ADDENDUM NO.: 3.0

DATE OF ADDENDUM: October 29, 2014

**Founders Hall Renovations for Allied Health and Nursing
Naugatuck Valley Community College, Waterbury, Connecticut
BI – CTC – 442 – CMR**

REVISED EGRESS NUMBERS

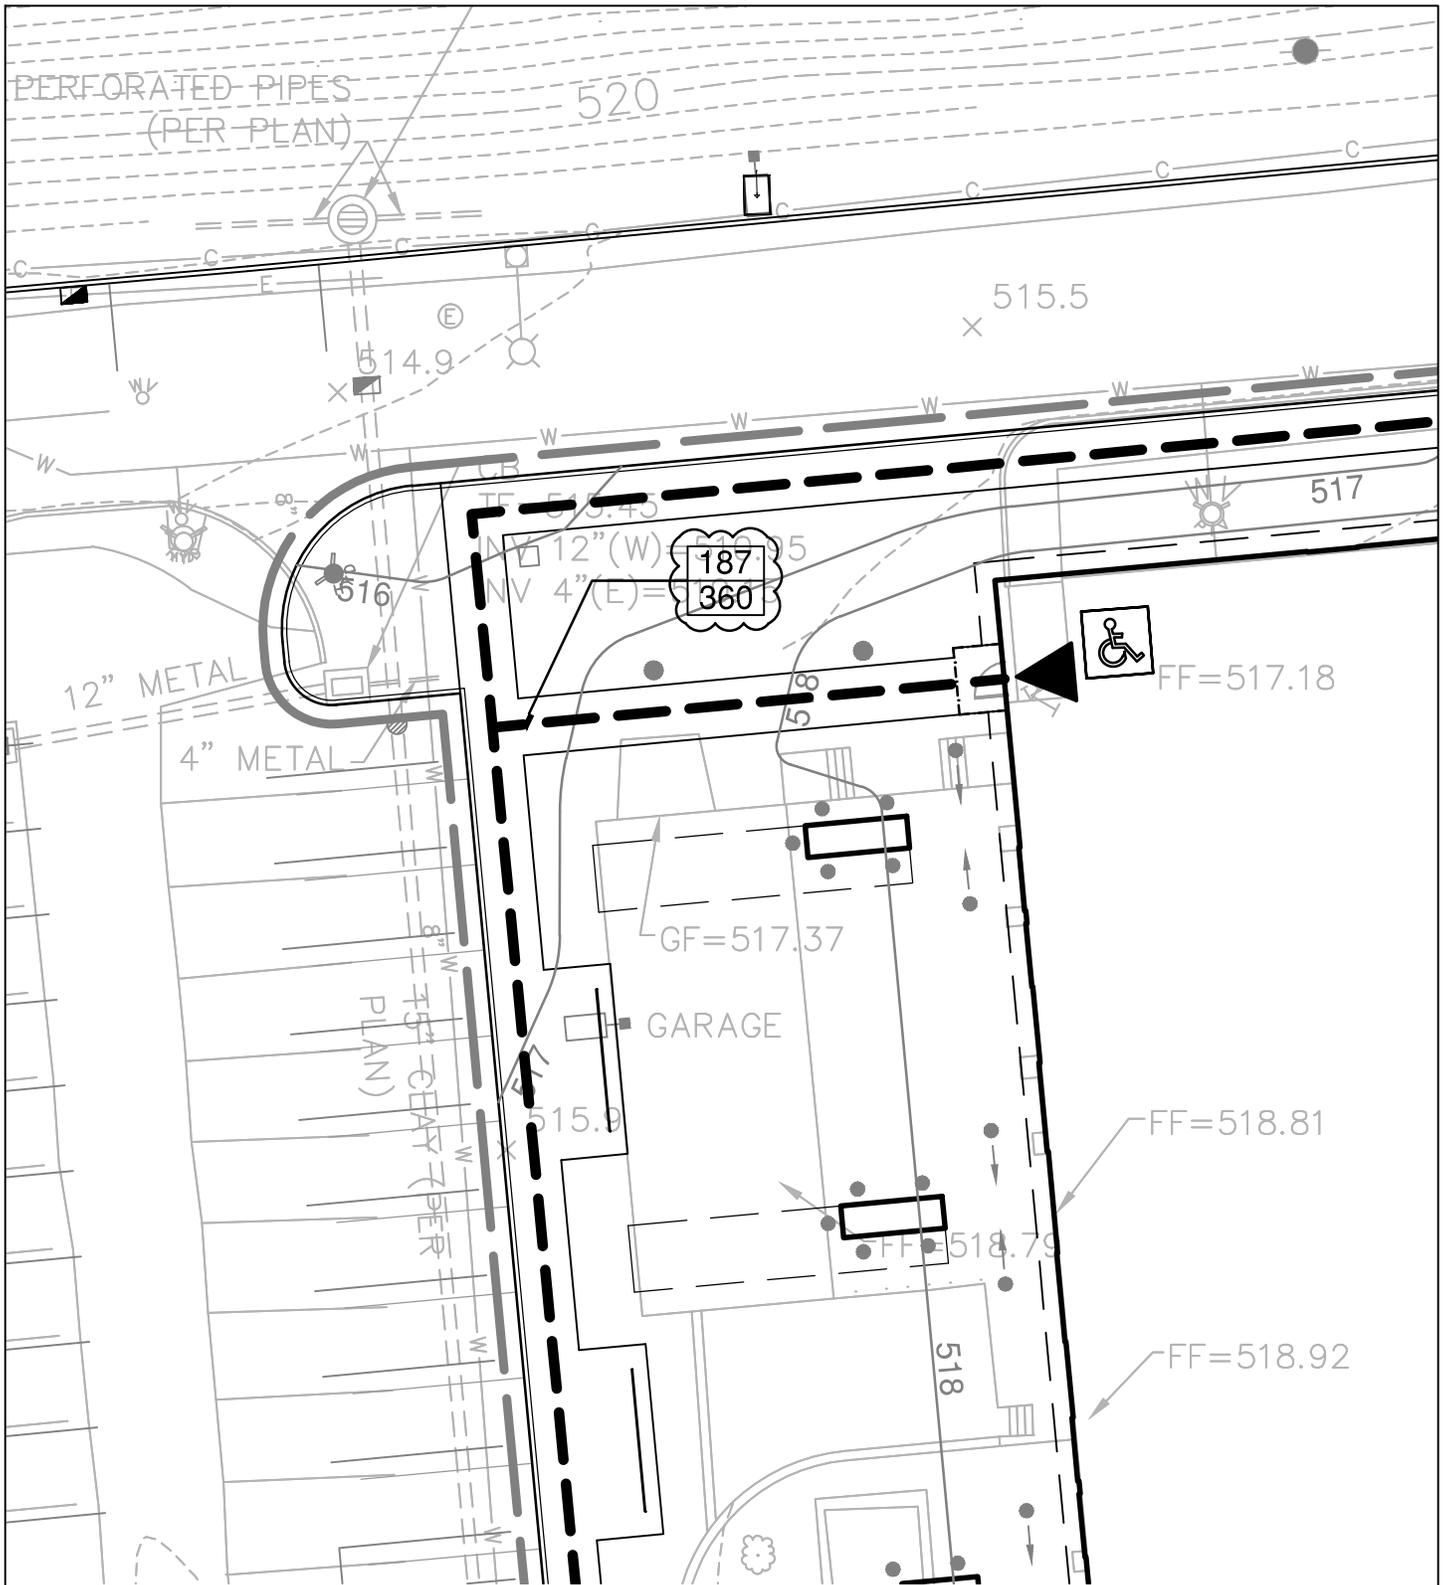
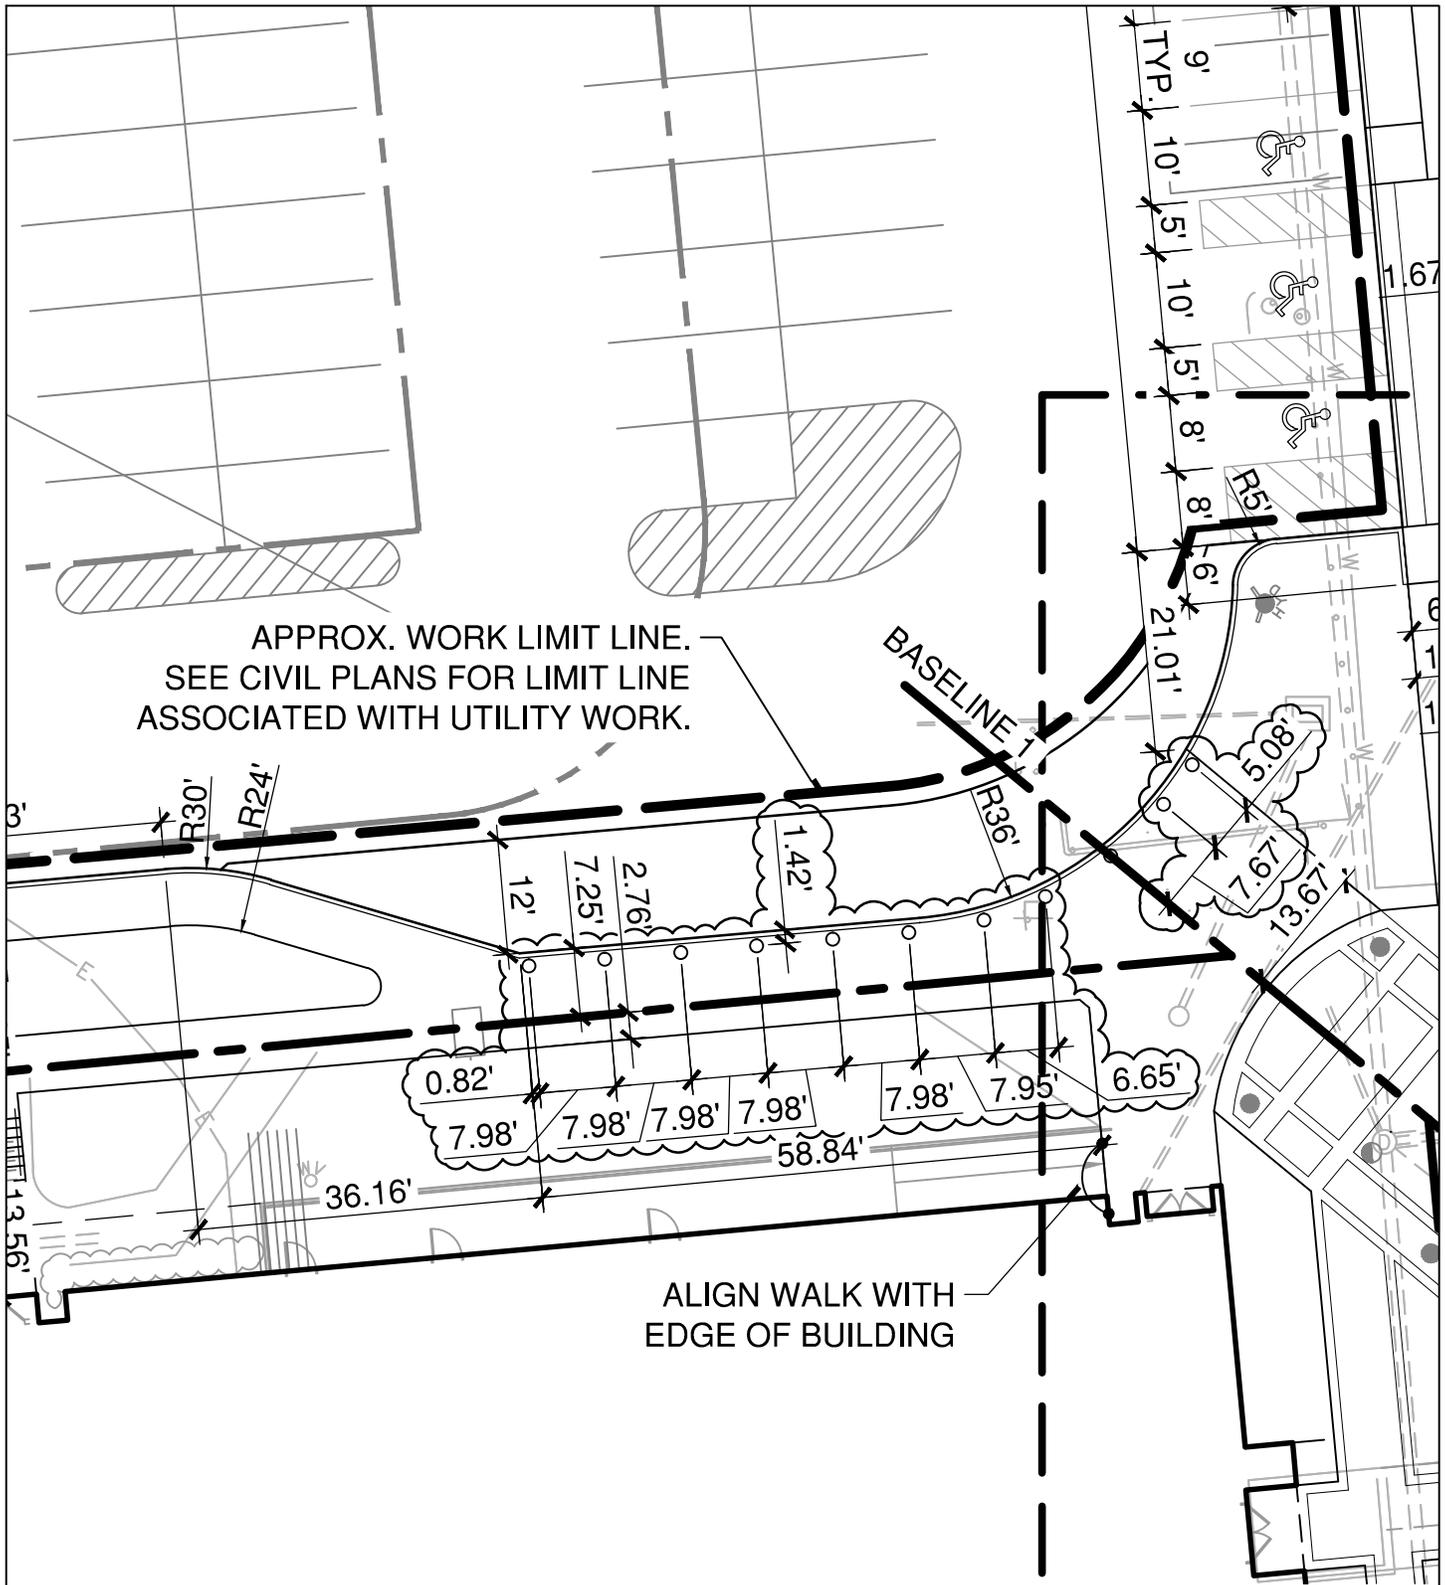
DRAWING CD-3 – SITE CODE INFORMATION AND EGRESS PLAN: **REVISE** egress numbers exiting the building as indicated on attached sketches AD3-SK-CD-3-1 and AD3-SK-CD-3-2 both titled “Revised Egress Numbers”.

SKETCH TITLE
ADDITIONAL LAYOUT FOR
GRANITE BOLLARDS

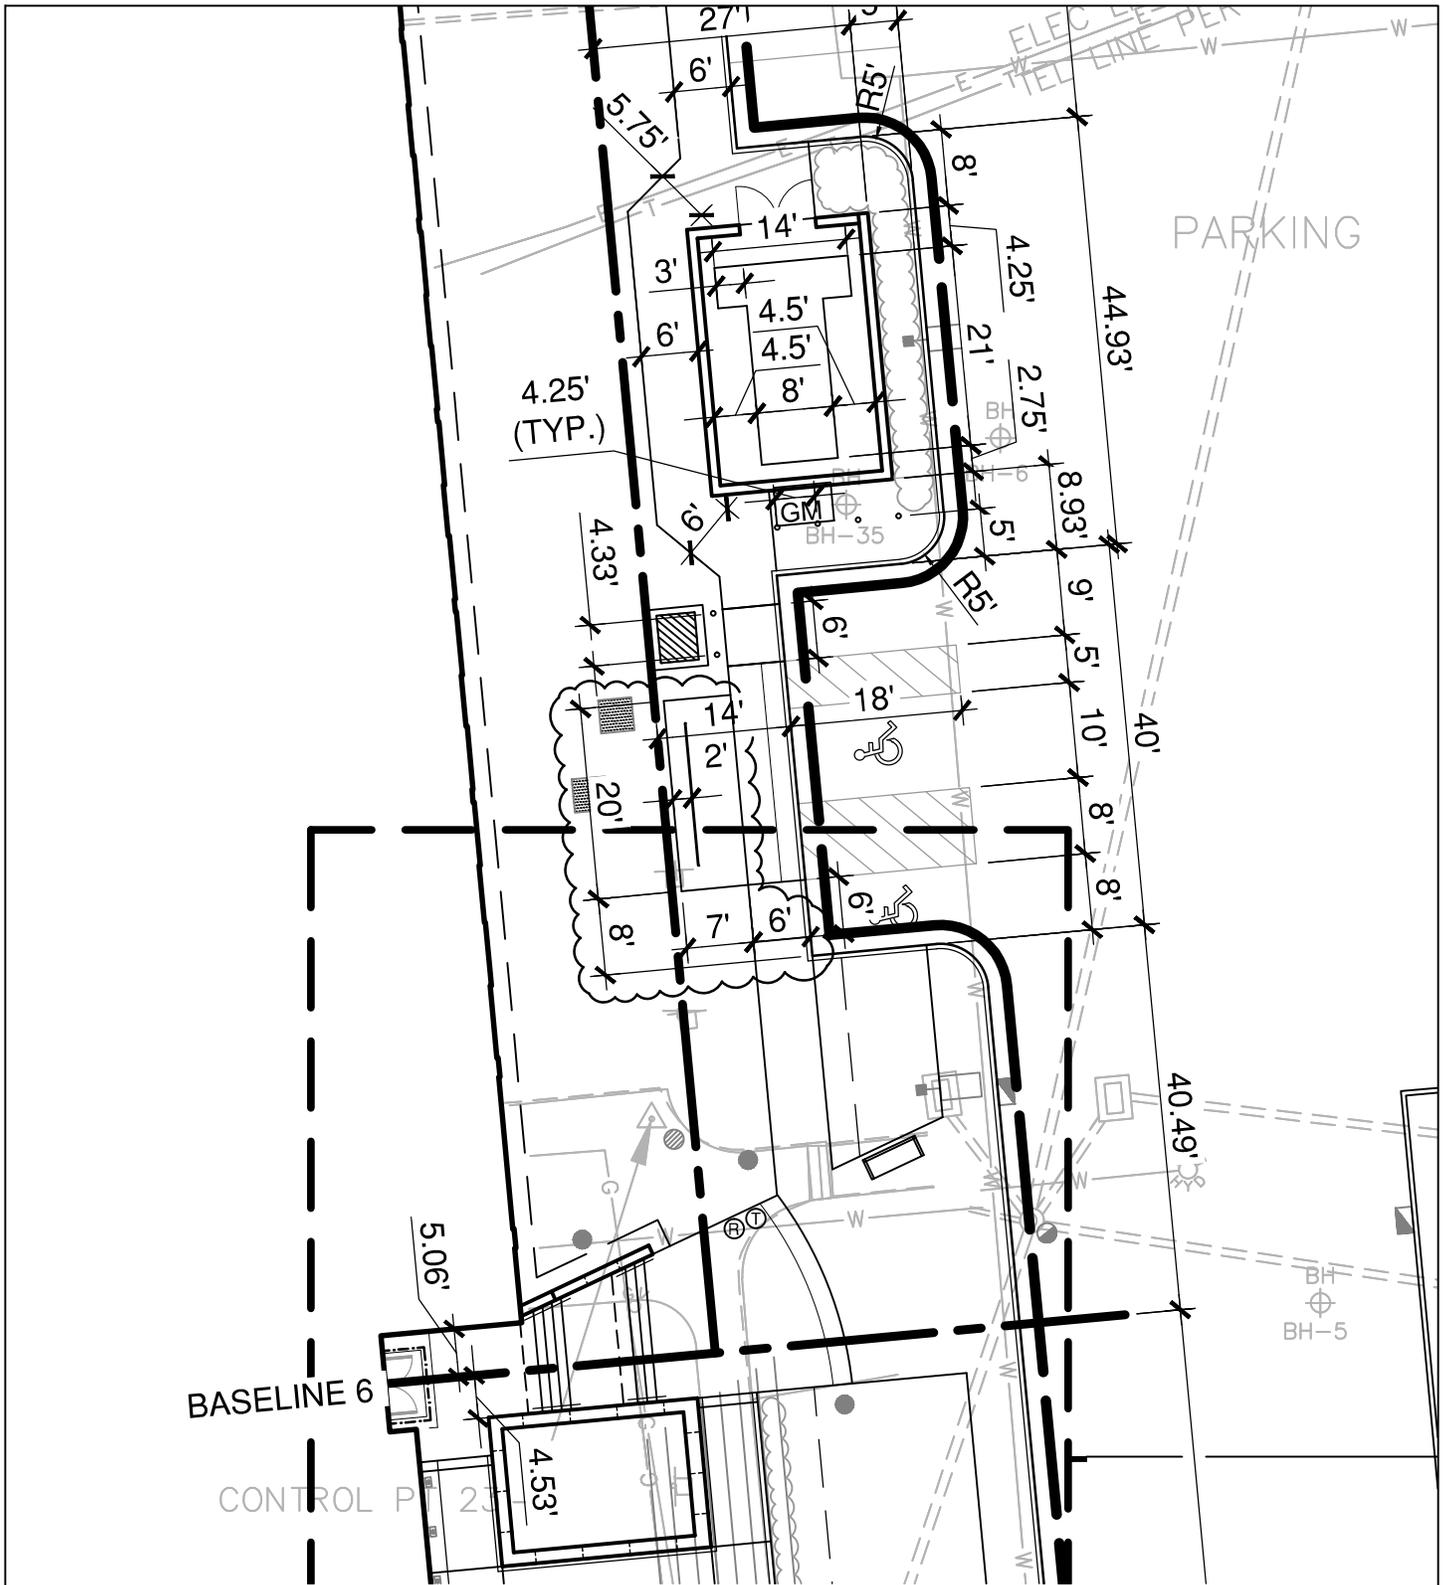
- a. **ADD** dimensions along west side of building as indicated on attached sketch AD3-SK-L-1.1-1 titled “Revised Bike Rack Layout”.
- b. **ADD** dimensions near main entrance as indicated on attached sketch AD3-SK-L-1.1-2 titled “Additional Layout for Granite Bollards”.

REVISED BIKE RACK LAYOUT

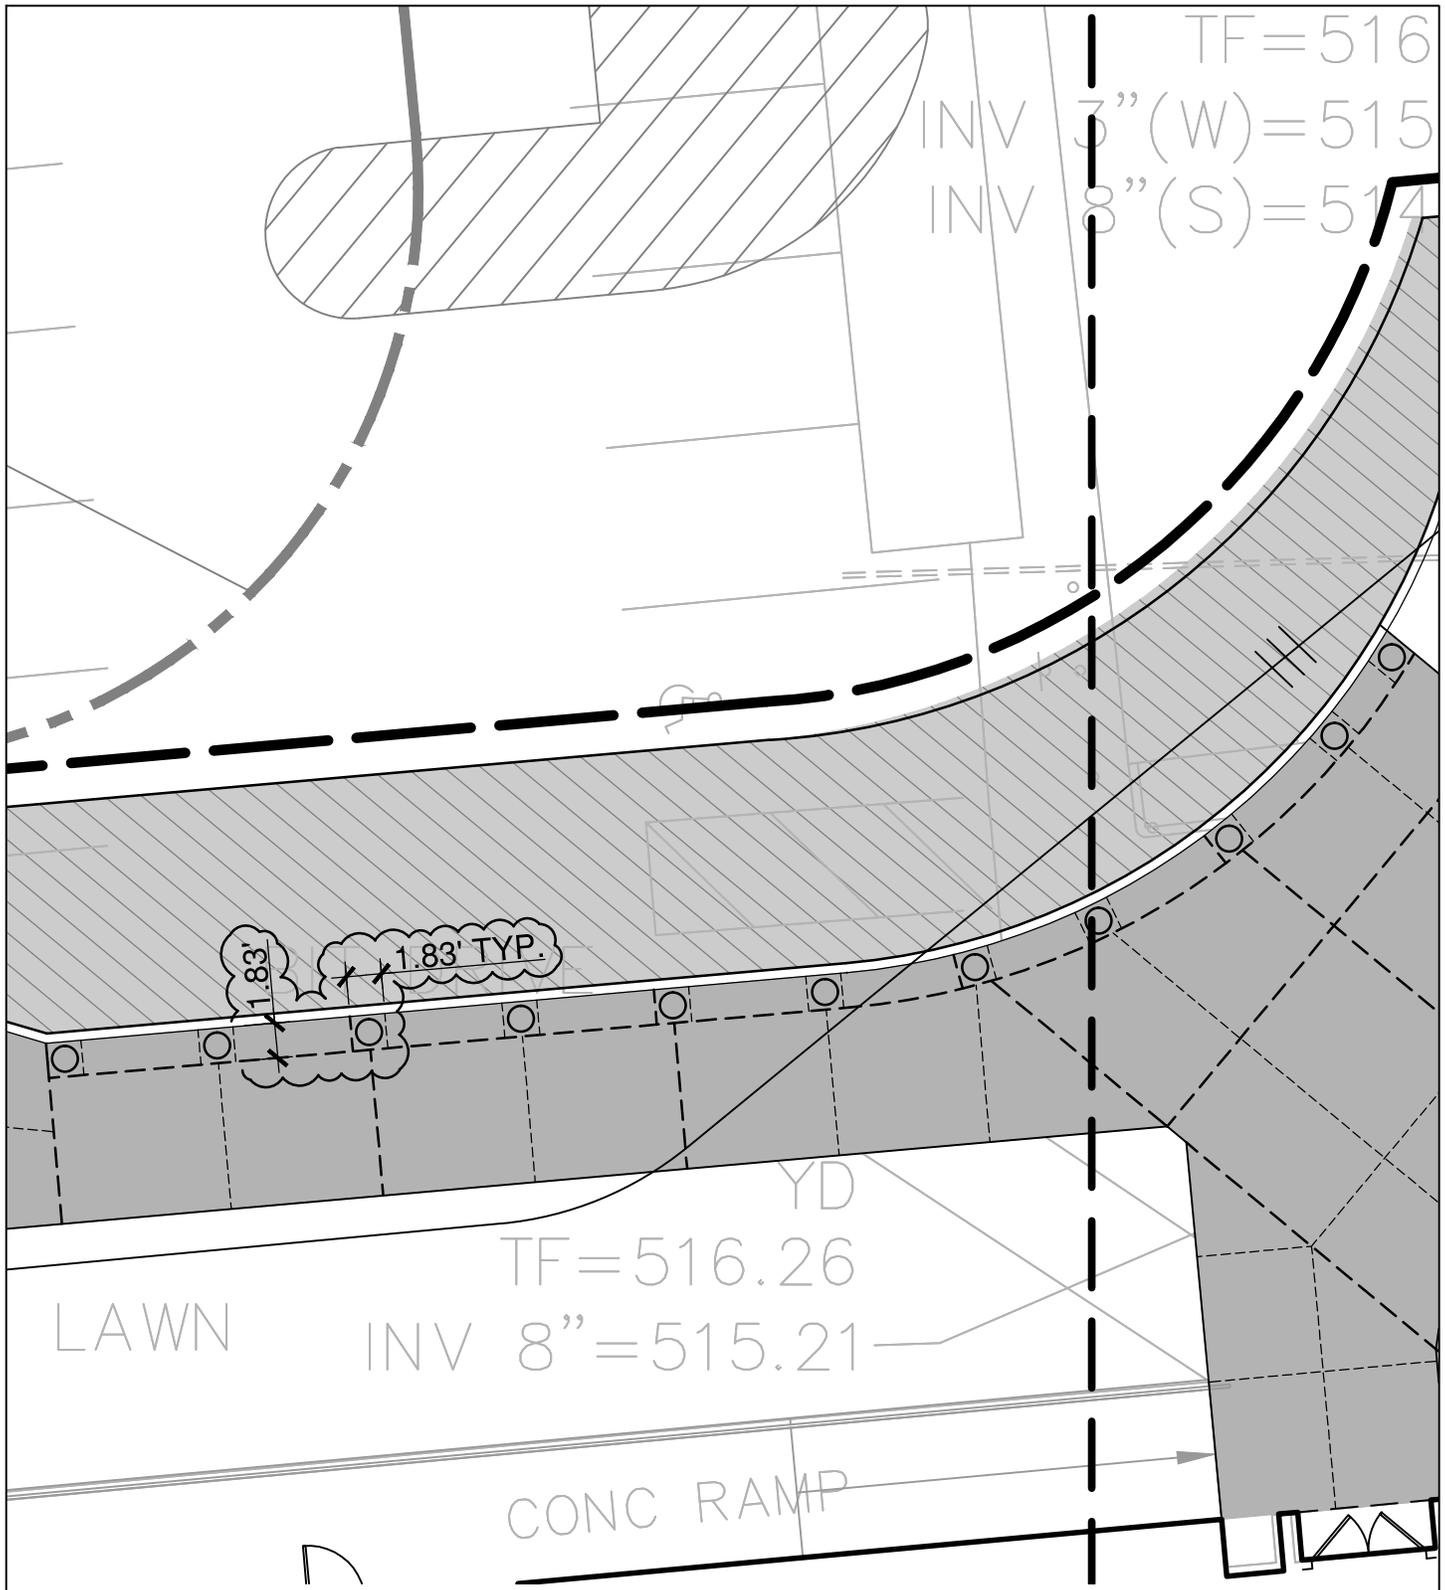
- c. **ADD** dimensions at southeast corner of building as indicated on attached sketch AD3-SK-L-1.1-3 titled "Additional Layout for Curb Ramp Width".
- d. **REVISE** dimensions at east side of building as indicated on attached sketch AD3-SK-L-1.1-4 titled "Revised Bike Rack Layout".
